Re: Addendum #1, IFB #: LED-01-24

To: All Potential Bidders
From: Kelly Vu, Business Services Supervisor
Re: RFI #1, Q & A, IFB # LED-01-24

The purpose of this RFI (Request for Information) is to transmit "Questions and Answers" regarding the technical components of the IFB Gate 1 Sign LED Board Replacement. All terms and conditions of the original IFB notice remain unchanged.

OVERALL ELEVATION DRAWING

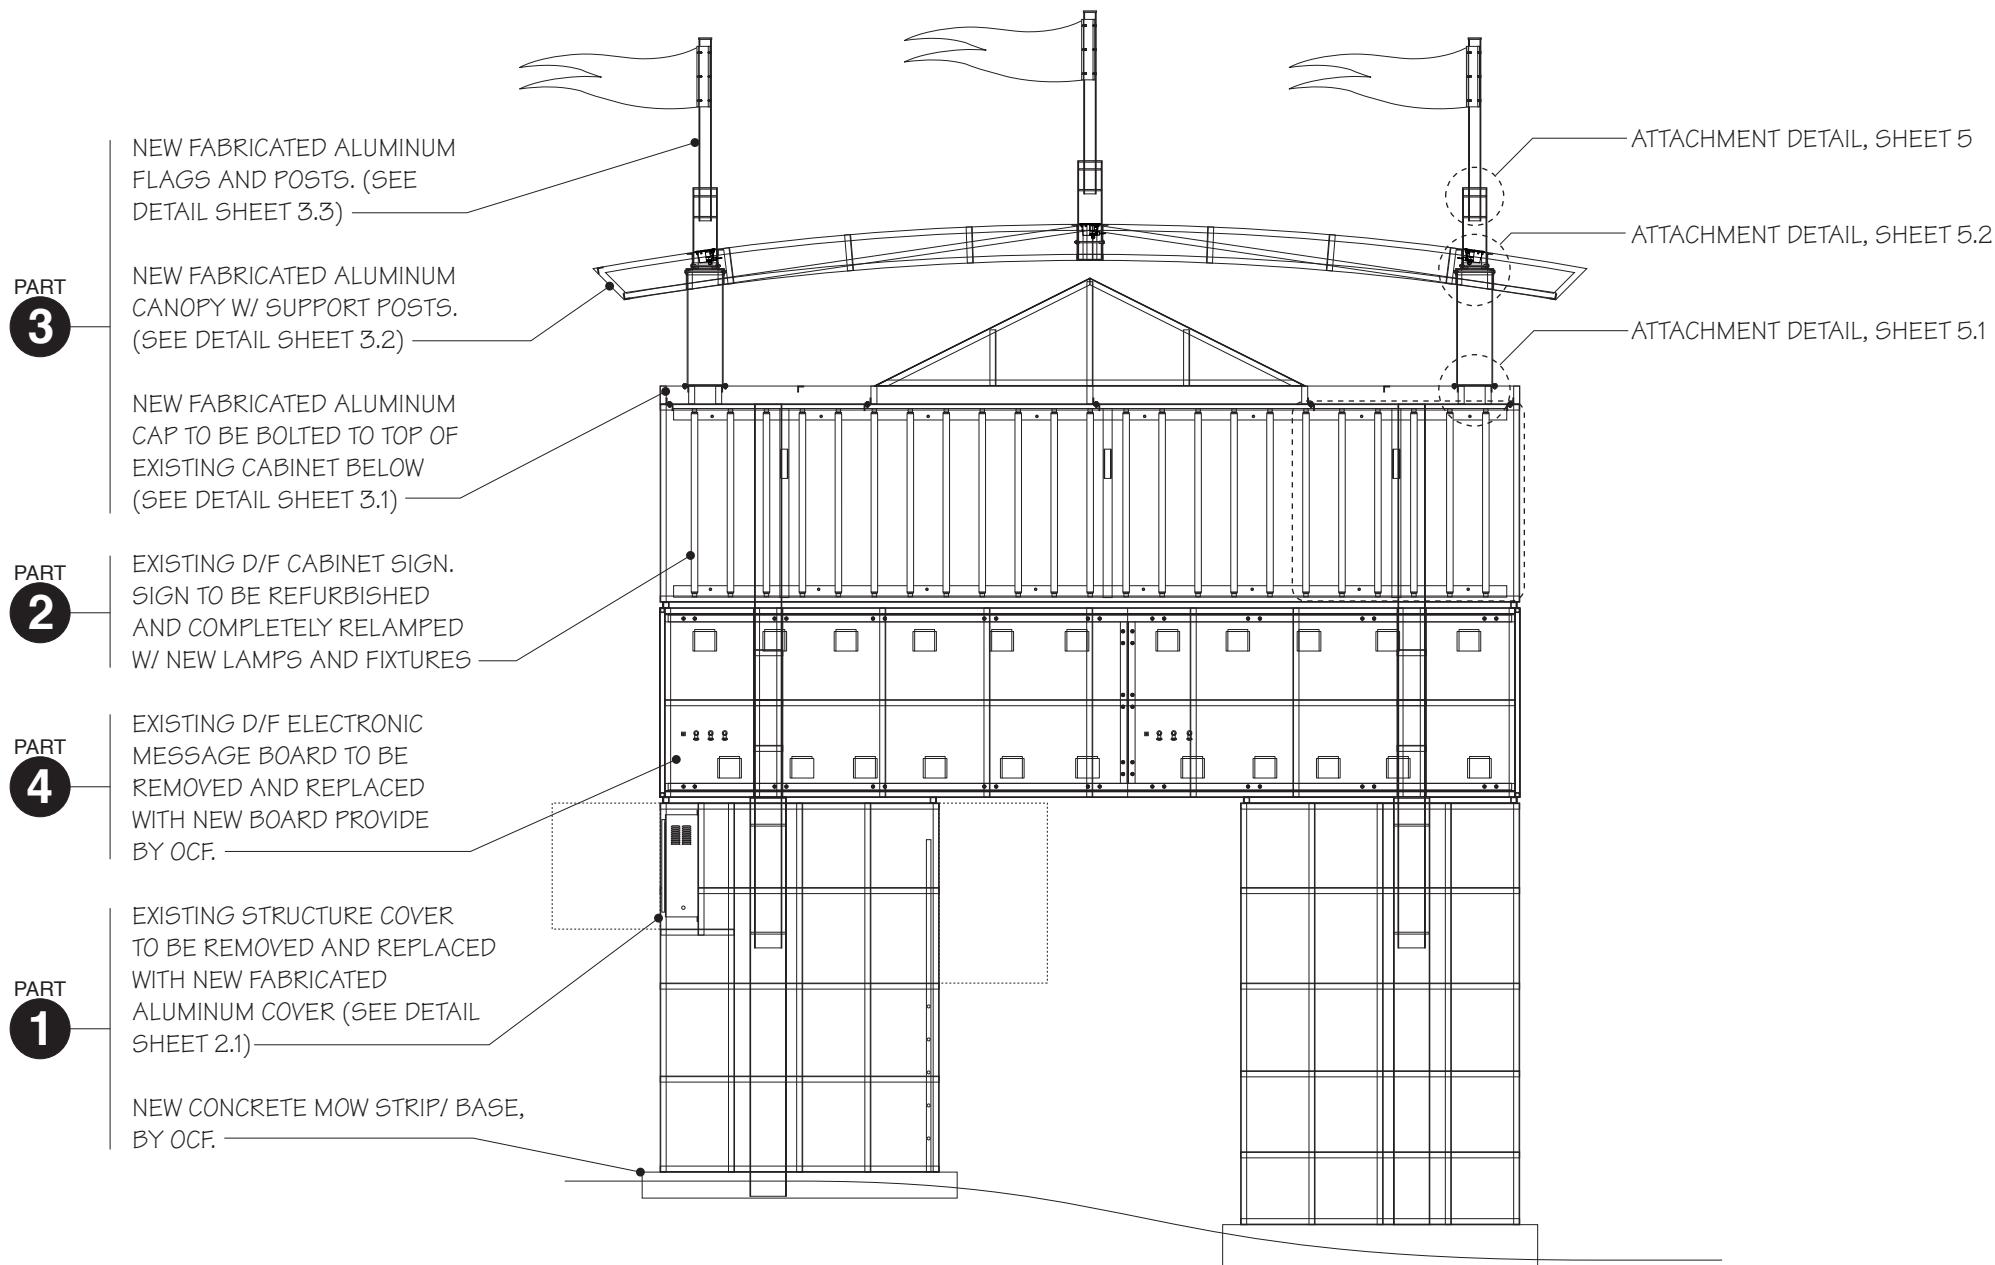
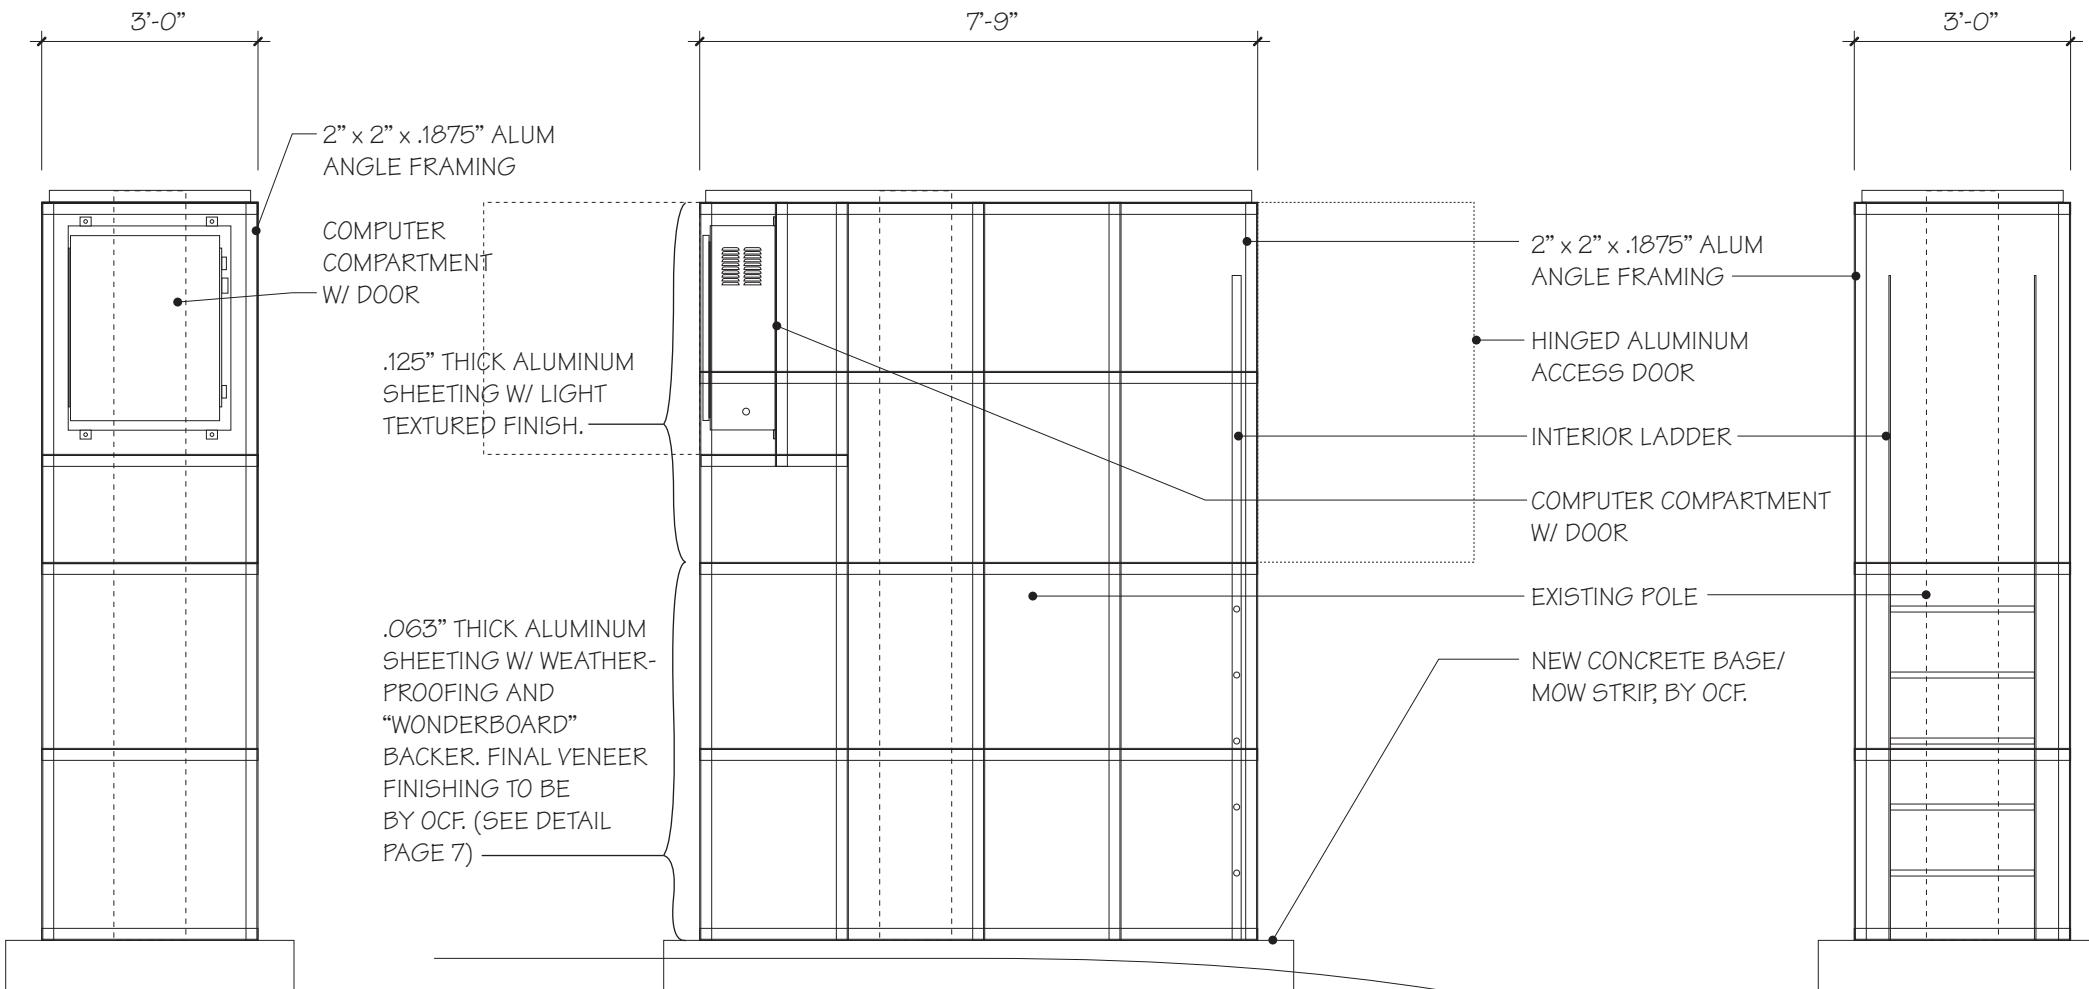
2. On page 16 of the attached PDF, the bottom sign elevation calls out "Part1 – Existing structure cover to be removed and replaced with new" "Part2- Existing D/F cabinet sign to be refurbished and relamped" "Part 3- New Fabricated flags, new fabricated canopy, new fabricated aluminum cap". Does all this scope of work need to be included in our bid? Or are these drawings just to show us what is existing?

11. Is scope of work only for item 4 on page 16, or are any of the other items (1-3) to be included as well?

Answer: The drawings provided on page 16 are for reference only to show you what is currently existing. Any mentioned scope of work in the drawing does not apply to this project/scope.

Answer: The drawings provided on page 16 are for reference only to show you what is currently existing. Any mentioned scope of work in the drawing does not apply to this project/scope.
